CITY OF NEW YORK
MANHATTAN COMMUNITY BOARD FOUR

March 6, 2023

Re: New York/New Jersey Harbors and Tributaries Study - Proposed Action Plans

Attached B

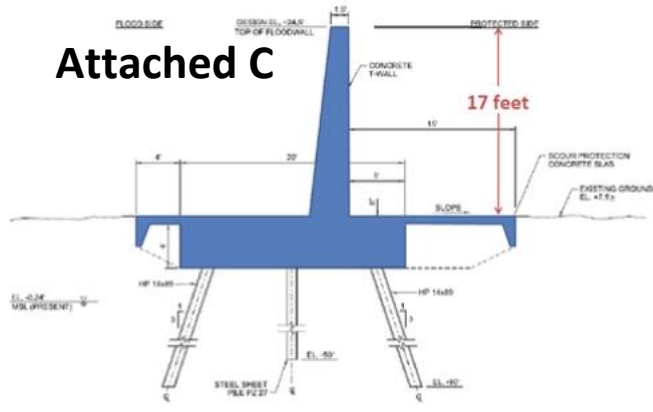
The Report contains multiple conceptual plans considered by the USACE to accomplish the goal of storm surge risk reduction and induced flood mitigation. The plan ultimately endorsed by the USACE (TSP) recommends building 11-17 foot high walls running parallel to the shoreline, from the southern edge of Community District 4 (CD4) at West 14th Street up to West 34th Street (attached A). Although representatives from the USACE stressed this was a conceptual and preliminary plan and no siting or details for such a wall has been determined, the rendering furnished by the USACE shows a concrete wall located between the walking and bicycle greenway path, adjacent to Route 9A, and Hudson River Park (attached B).

Certainly, MCB4 cannot support the TSP as presented. The effects of building a massive, unsightly wall along the western edge of Route 9A will cut off CD4 from not only the Hudson River but also from Hudson River Park.

A 15+ foot wall serving as a grotesque obstacle between a community and its greatest green space would undo two decades of development of Hudson River Park. Cutting off the waterfront park from the community with a fixed, solid wall would return to the days of physical separation of residents, many low-income, from green space and, ironically, prove environmentally disruptive. Further, many of the park's features would be disfigured or destroyed by unsightly berms and barriers.

MCB4 strongly urges the USACE to reexamine the TSP and include coastal storm risk management elements of alternative plans 2 and 3A, utilizing an offshore barrier system, which may include sea gates.
